REQUEST FOR FURTHER INFORMATION RESPONSE DOCUMENT
FOR ADAMSTOWN SDZ PLANNING APPLICATION:
ADERRIG PHASE 3
MARCH 2022

CONTENTS

1.a Phase 4 Indicative Layout - Height Requirements

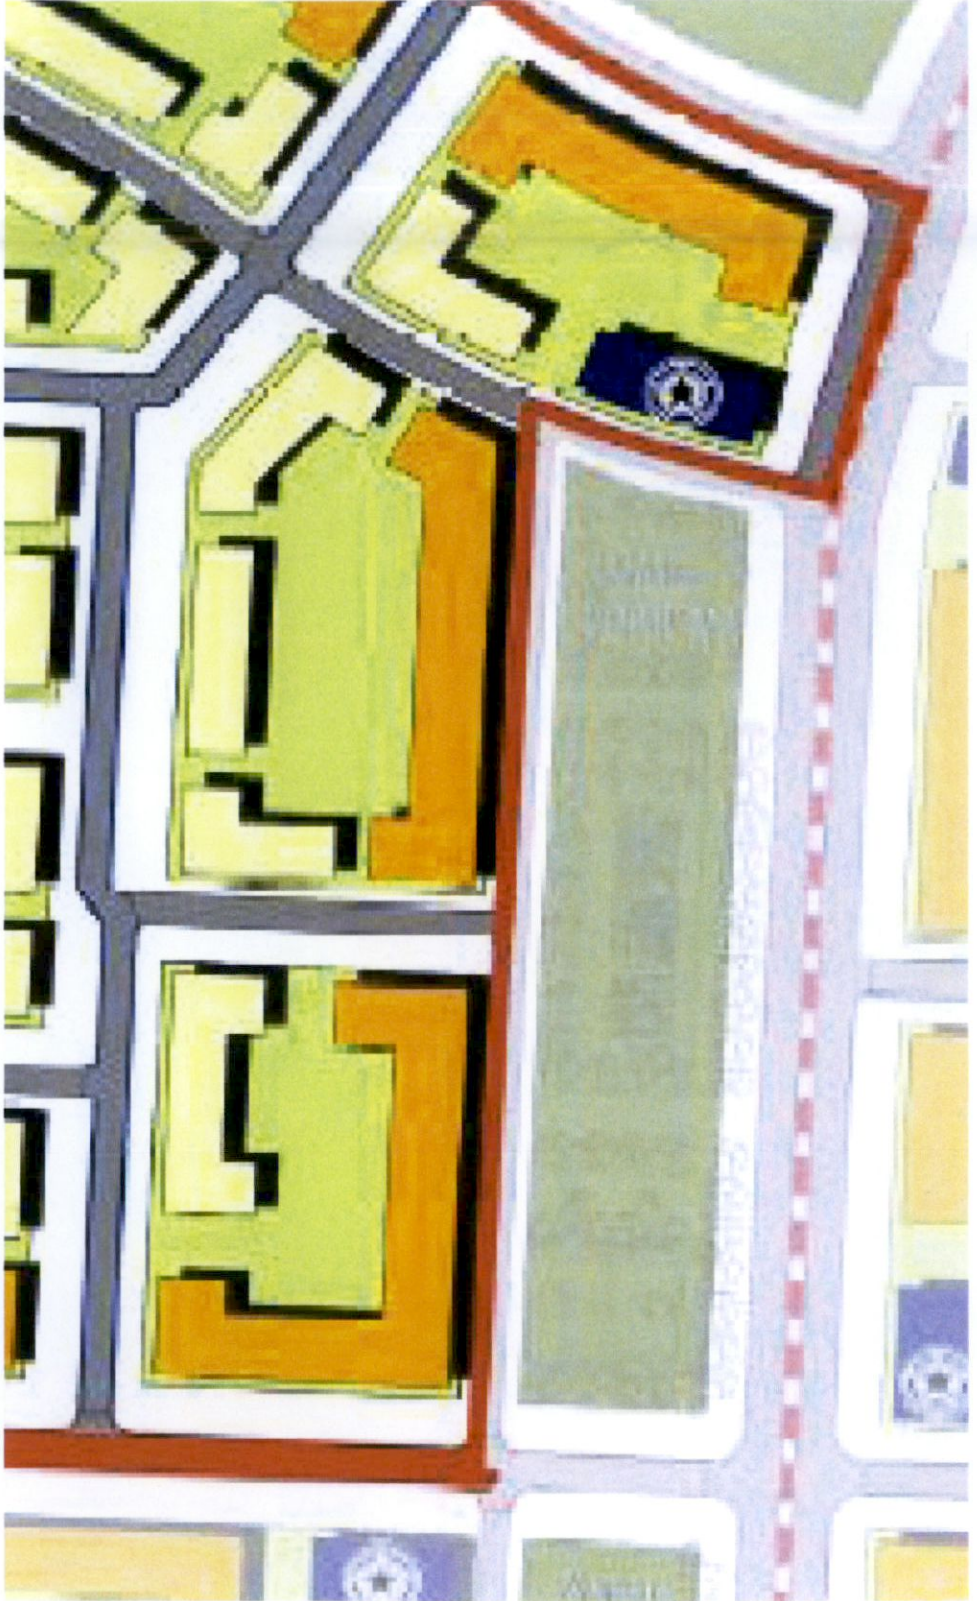
Requested AI:
The Applicant's proposal regarding density may be acceptable. In order to determine this, the applicant is requested to provide the following information:
a. an indicative layout for Phase 4 that:
• Is in keeping with the height requirements of the scheme,
• Sets out the number of units and density (% of 1bed apartments should also be set out)
• Provides details of the density of Phases 1 and 4 as a single development site (if changed)
• Provides details of the overall density for the development area (if changed)

Response:
The additional information package includes an overall Aderrig phasing plan incorporating phases 1 to 4. Phase 4 is proposed to provide 337 units and has been presented to SDCC at pre-application meetings. At the time of this response, phase 4 unit numbers remain at 337 units.
Please refer to Aderrig phasing map (page 6) and table (page 7) which demonstrate the overall density of 60.1/ha which is in line with the SDZ range of 52 - 70 per ha'

This page illustrates the heights of the proposed phase 4 scheme which is in accordance with the SDZ diagram and the density for Phase 4 in the scenarios outlined in the AI request.

Blue line of net developable areas overlaid onto an extract from SDZ - 'Net Development Areas, Landmark Buildings and School Sites'

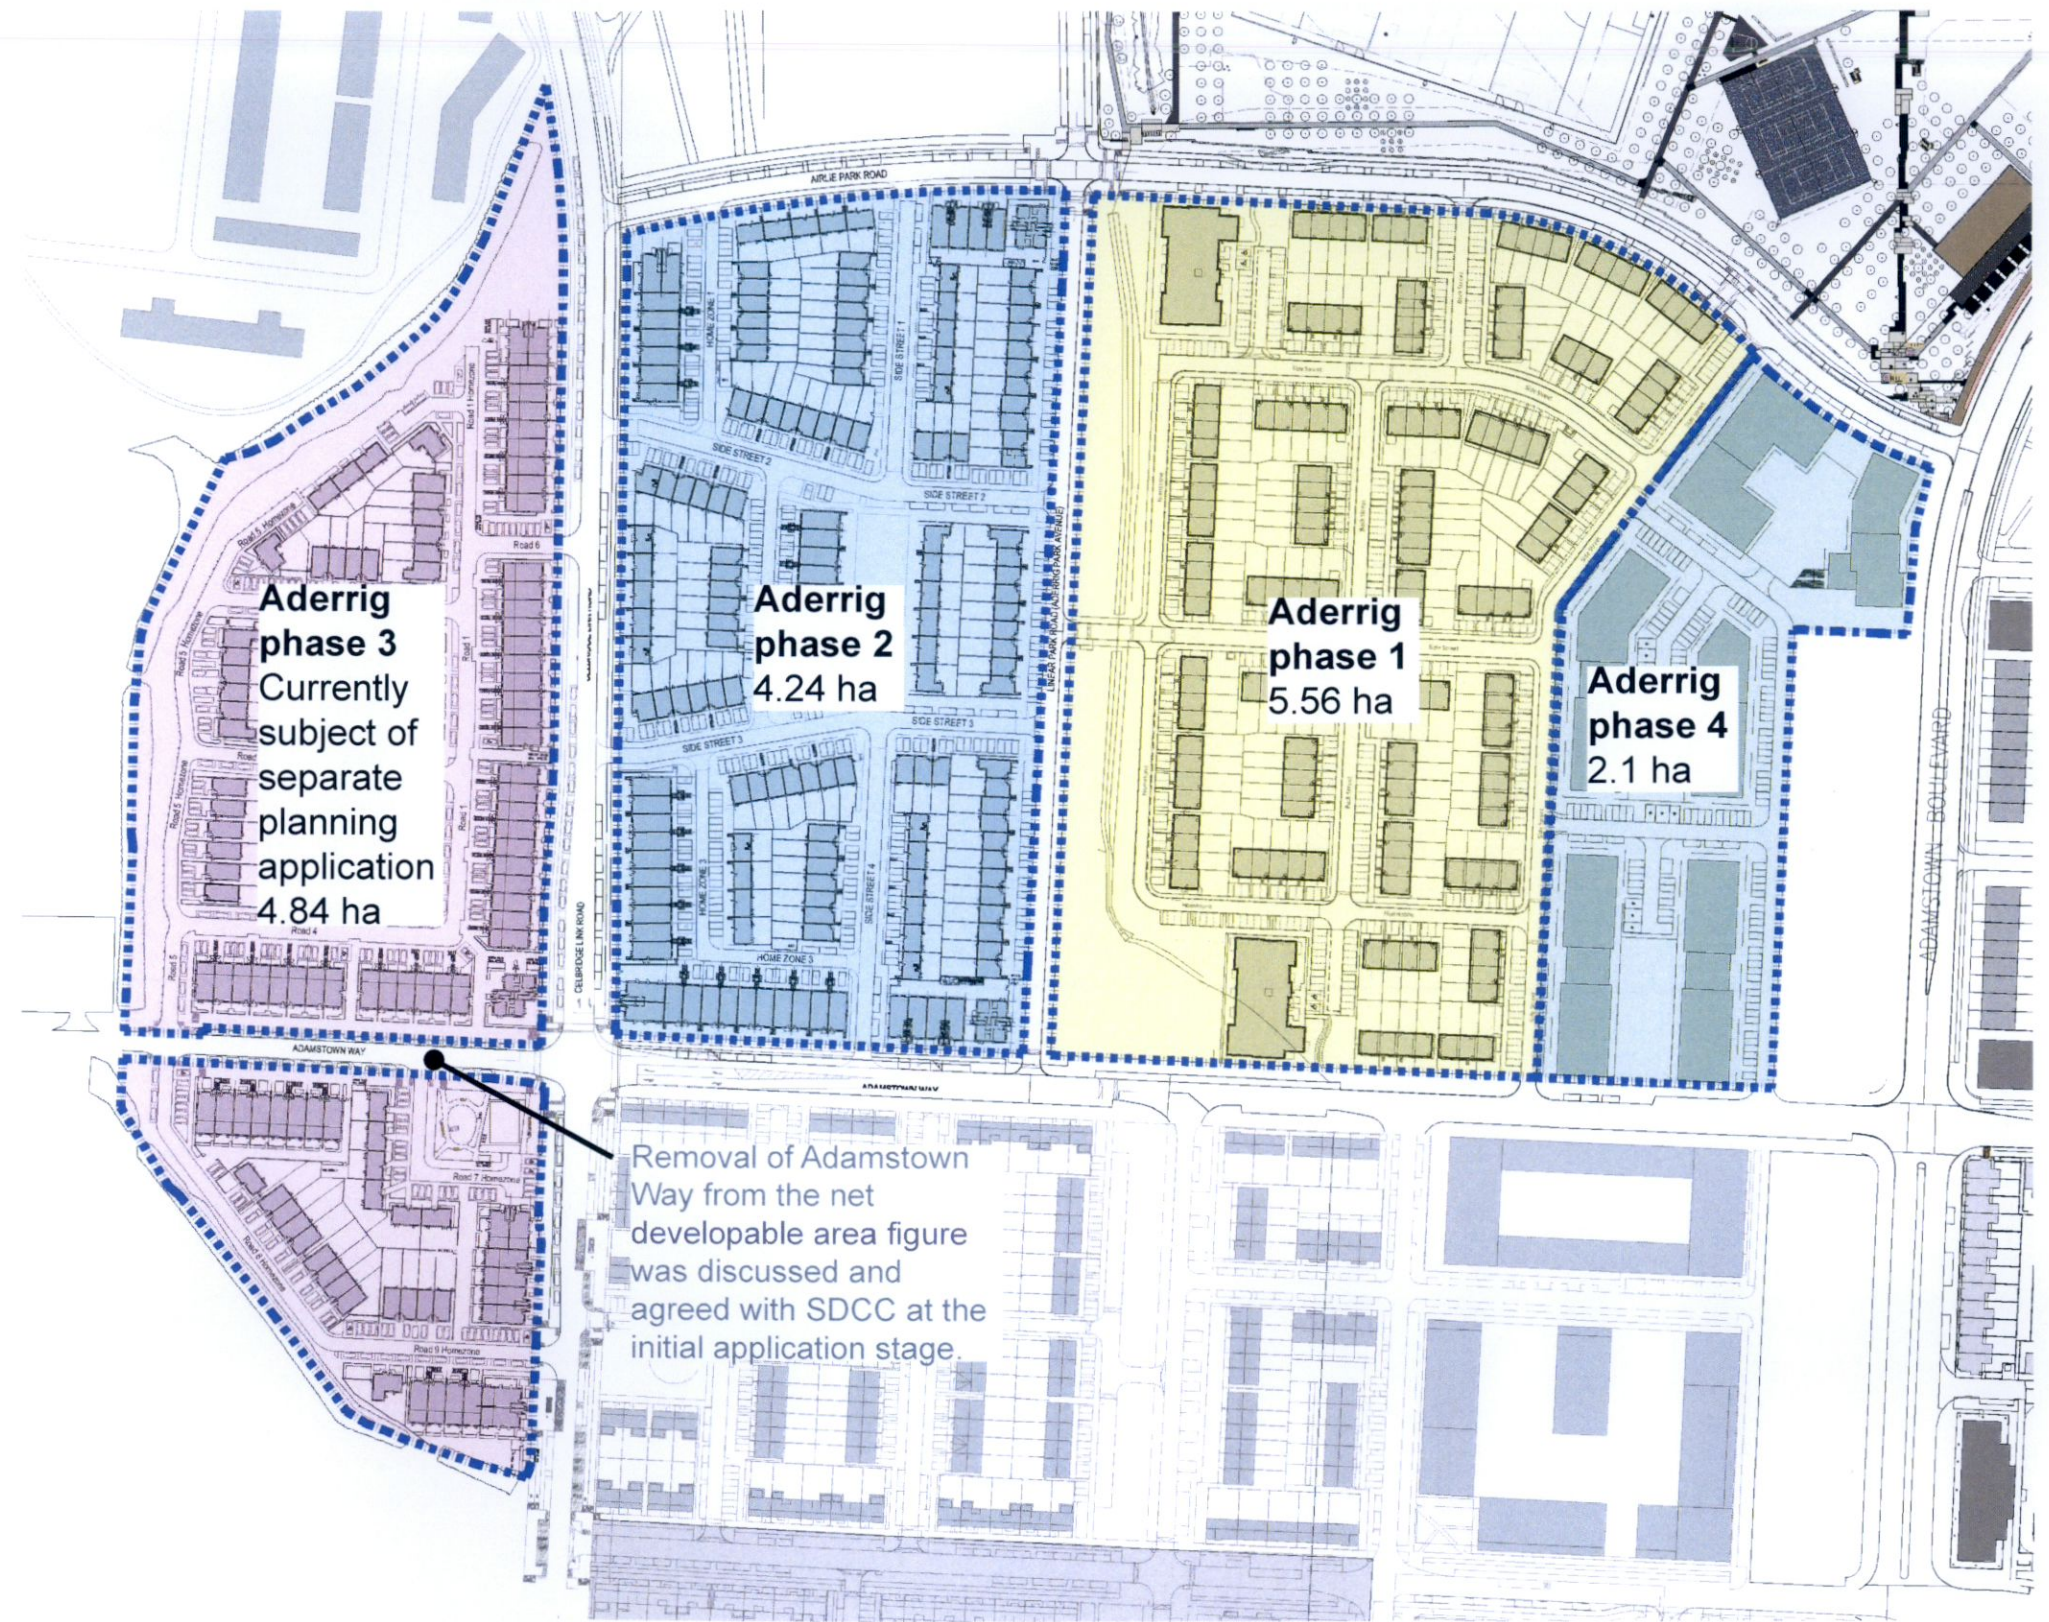
1.b. The applicant is also requested to provide a plan indicating Net development area for the current proposal and for the wider Aderrig area. This should be annotated with areas in sq.m / ha, as relevant.

The diagram shows the net development area for all phases of Aderrig. See also table below outlining the figures for each phase.

Please note that the difference between the Planning Scheme's NDA and the Total of the 4 No. phases is the omission of Adamstown Way as it cuts through Phase 3 (as it is designed to the same width as an 'Avenue') and the public open space / Primary school lands to the north, as previously agreed with SDCC.

Duplex Type G1 - example of storage areas indicated on the unit type drawings.

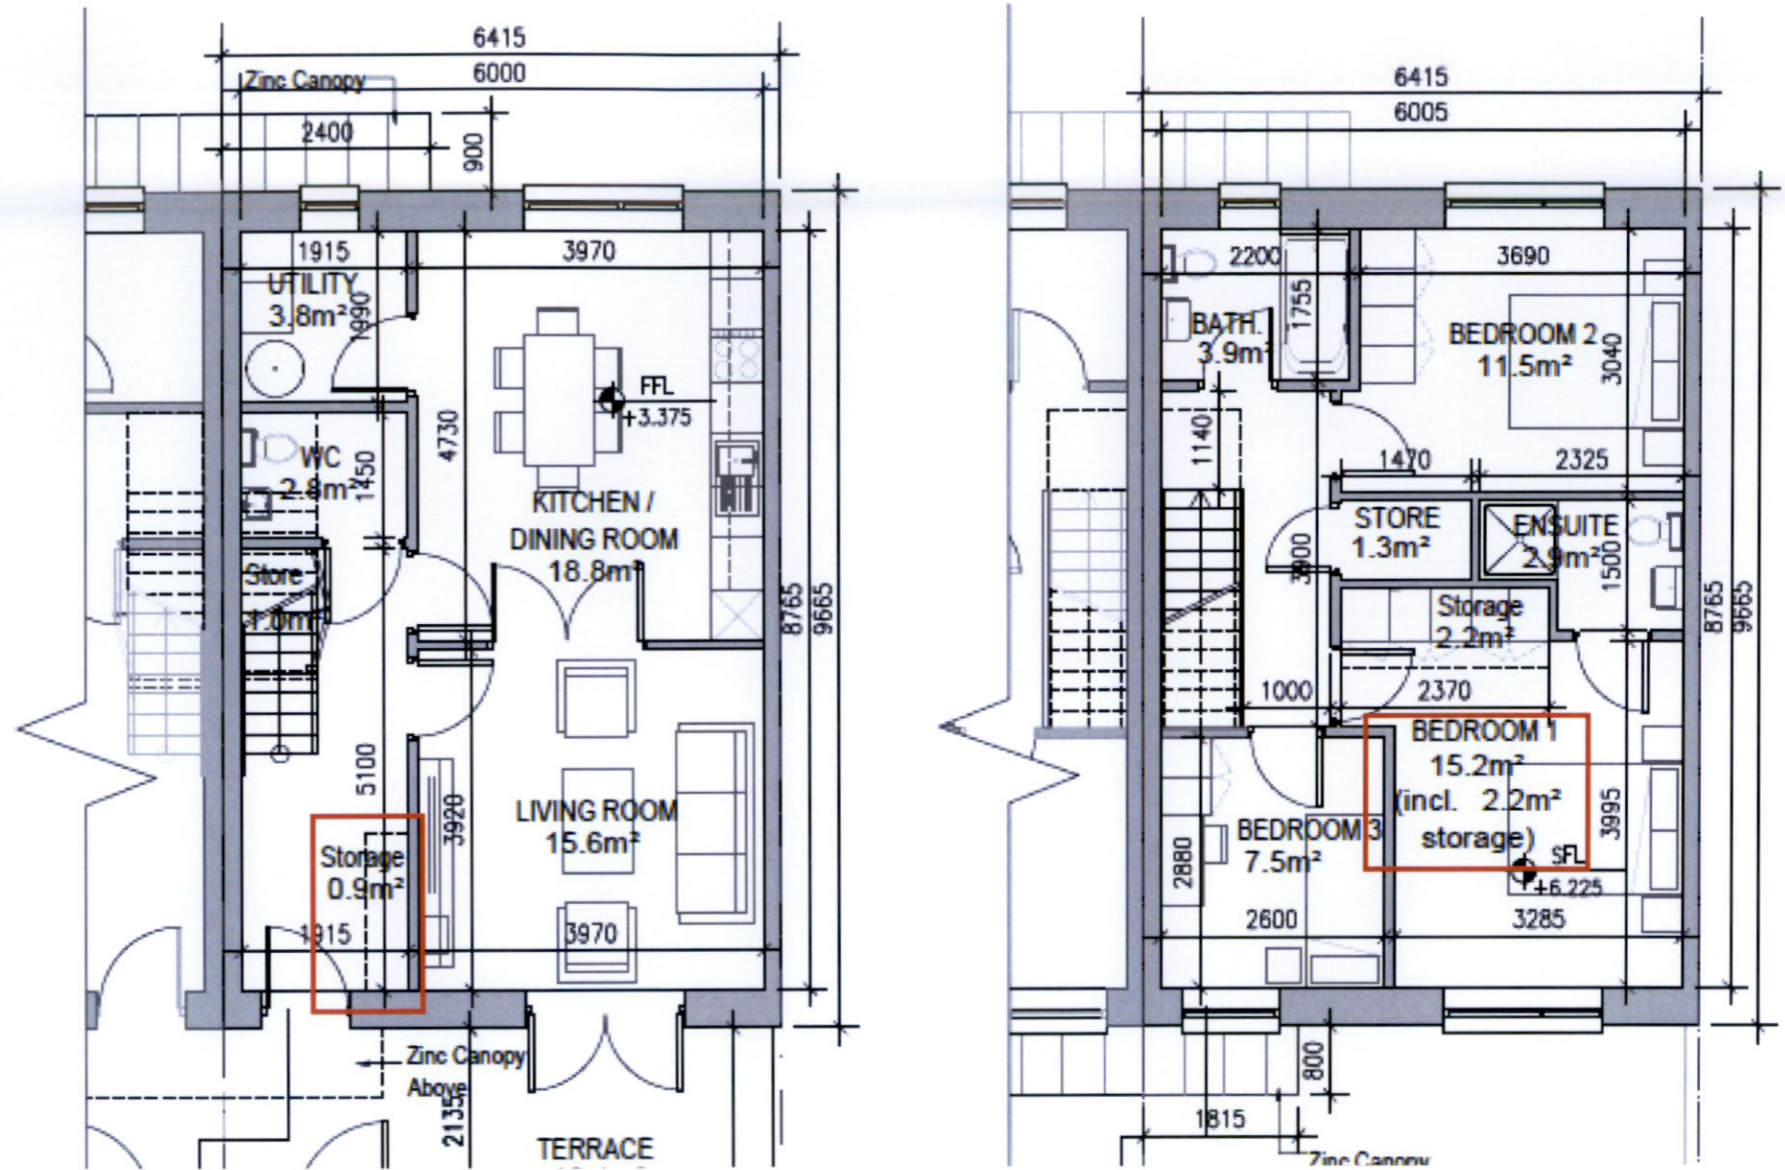
2. a. There is no indication in the relevant guidelines that the attic space is considered 'storage', in terms of dwelling design. The applicant is requested to reconsider the storage for impacted units and provide revised floorplans and elevations, where relevant.

Some units already had sufficient storage without having to rely on the extra attic storage. These have been updated in the Housing Quality Assessment document.

Elsewhere, the storage allocations have been re-measured where necessary, and storage locations labelled on the unit type plan drawings.

The unit type drawings have been updated where changes have occurred to adjust for storage and the HQA has been updated to reflect these revised measurements.

The following unit types were updated to show storage areas labelled in the plans in lieu of the attic storage:

Unit Type: A2

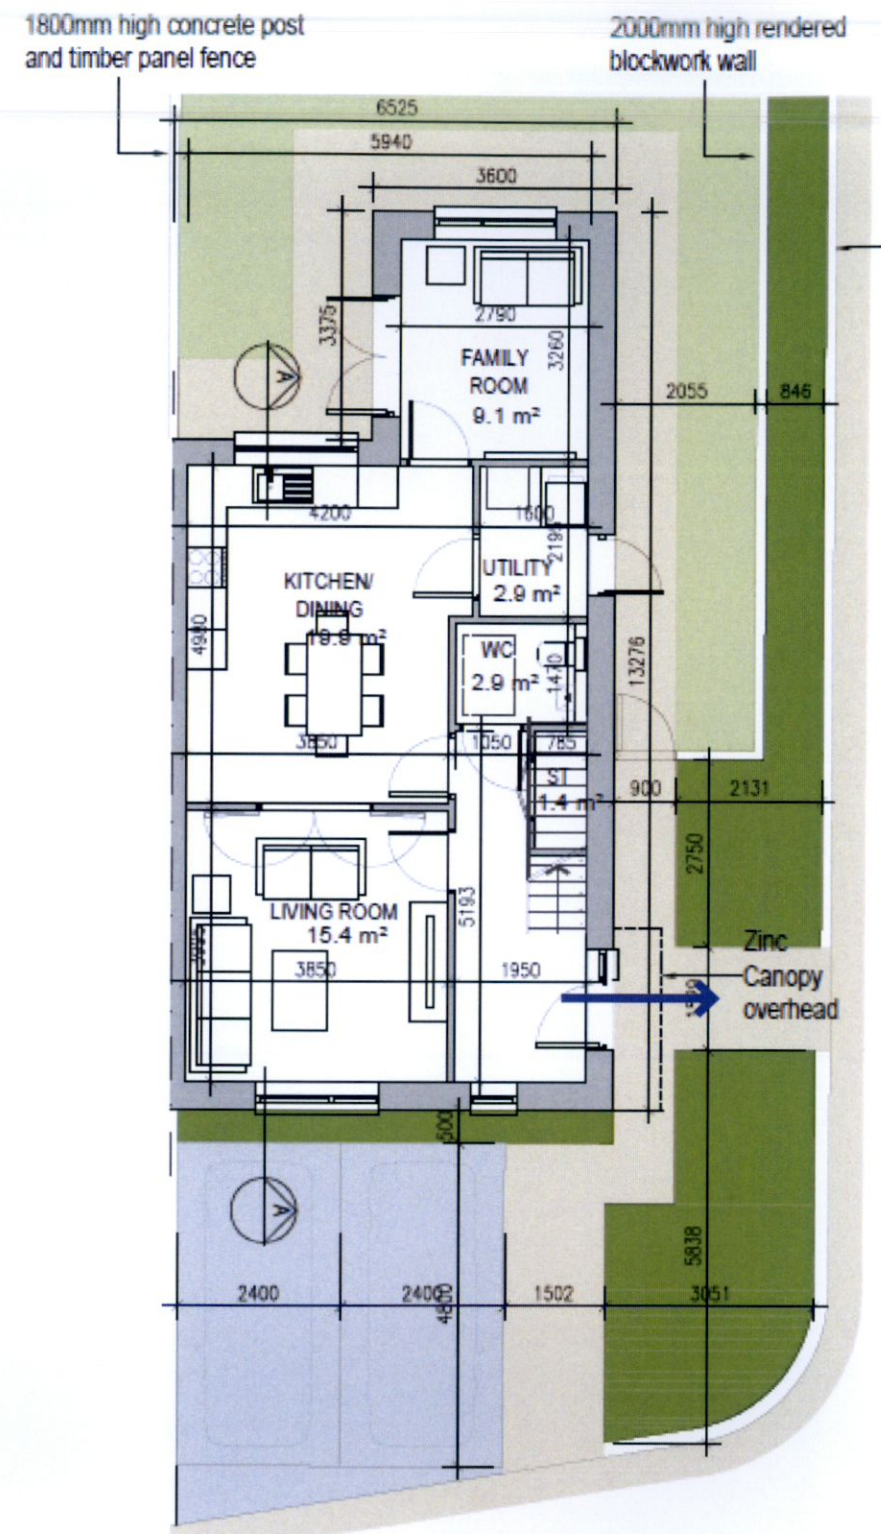
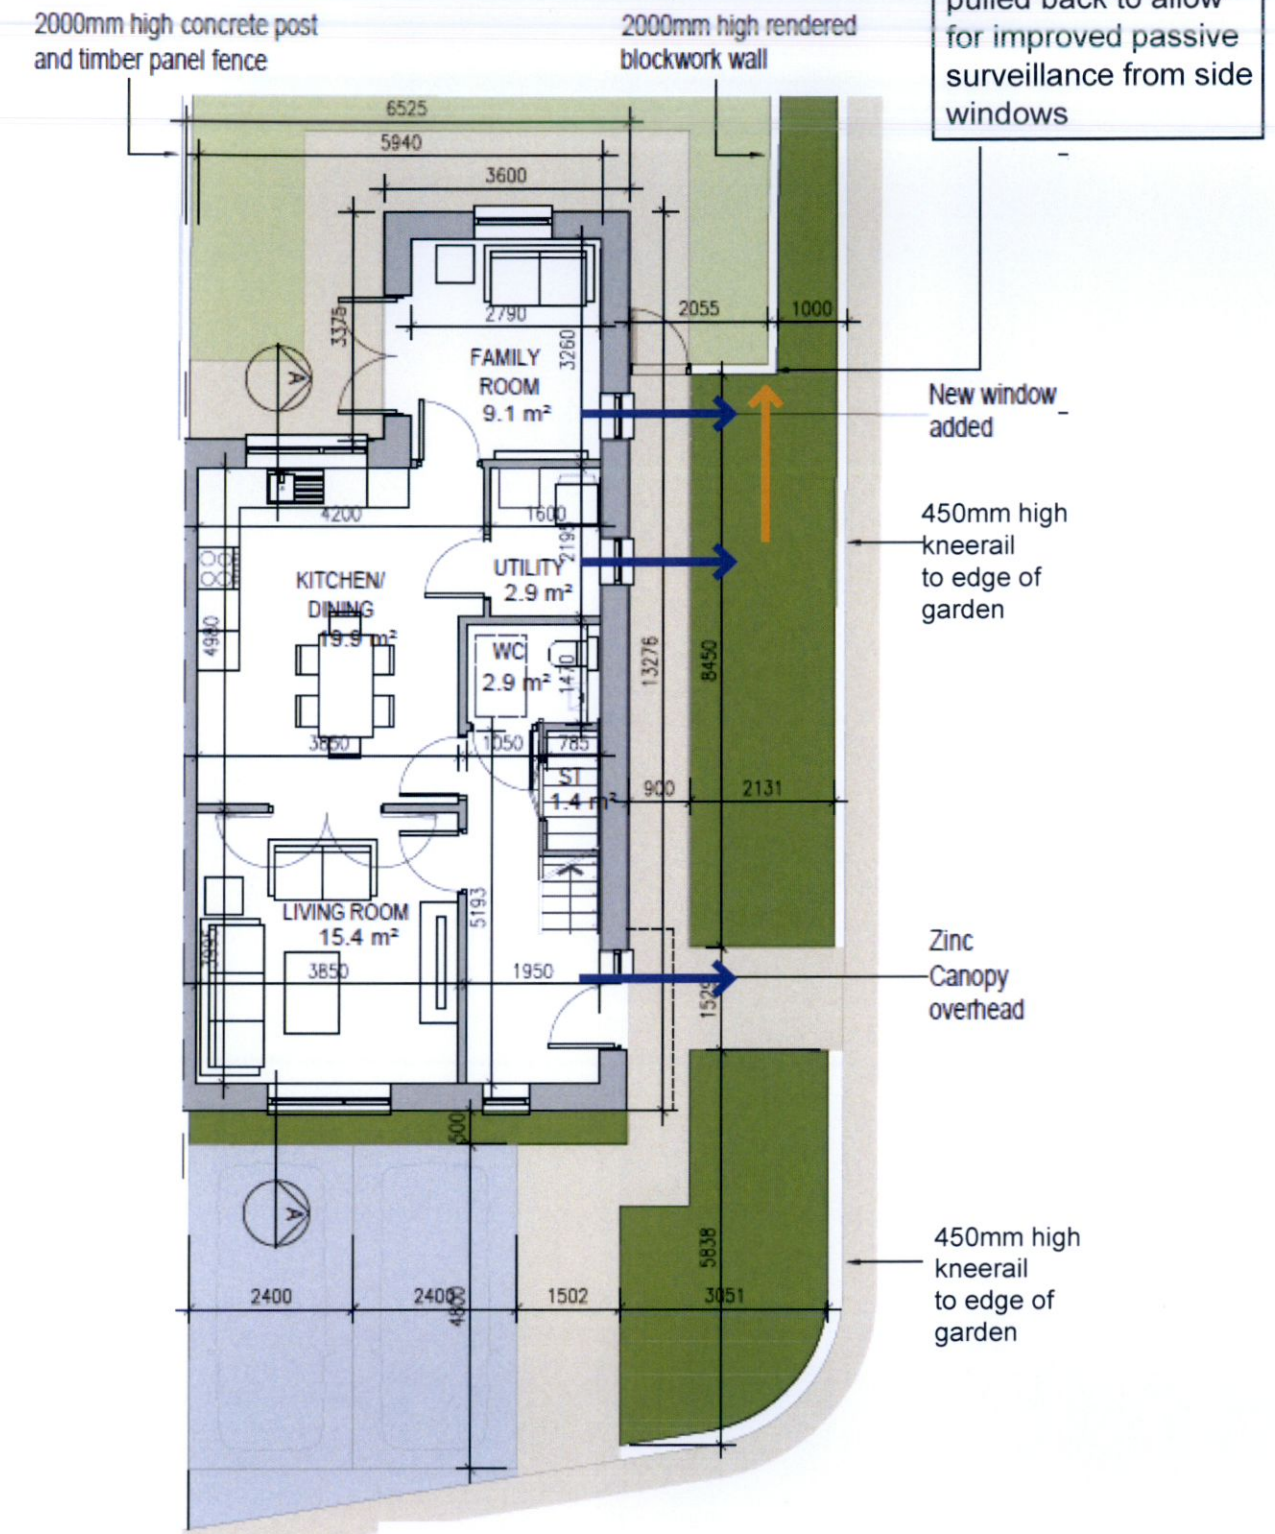
2.b. Passive surveillance could be increased by making properties dual frontage. It is noted that doors have been provided to the side of some properties.

Dual frontage / passive surveillance should be increased on the following house types:

- A2
- E2
- K1

Passive surveillance has been reviewed on the street side of the proposed units A2, E2 & K1. Windows to the ground floor have been improved and /or side garden walls have been pulled back and a 450mm kneerail or a 900mm railing allowed for instead. This allows windows to view out over the adjacent street. See revised unit type drawings for types A2, E2 & K1.

- Passive surveillance
- Garden wall pulled back to improve passive surveillance opportunity
